County of Santa Clara

August 19, 2021

FILE NUMBER: PLN21-114
SUBJECT: Building Site Approval on Slope 30% or Greater and Grading Approval
SITE LOCATION: 0 Helen Way, Los Gatos, CA, 95033 (APN: 544-39-035)
DATE RECEIVED: July 20, 2021

Fig. 4.20-2
Parking Structure
—Sloping Lots

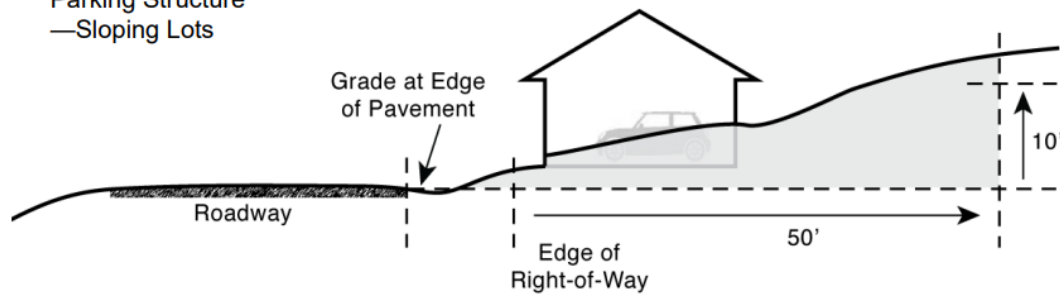
- a. A section drawing cutting through the Redwood Drive roadway and the proposed garage. The section cut shall extend a minimum of 50-feet beyond the edge of the right-of-way. Pursuant to Zoning Ordinance 4.20.020.(F).(1), “Where the grade elevation at a point 50 horizontal feet inward from the edge of right-of-way differs 10 vertical feet or more from the elevation at the adjacent edge of pavement, a garage, carport or other parking structure may be located within the required front or side yard of a lot.” (see Fig 4.20-2 inserted from Zoning Ordinance).
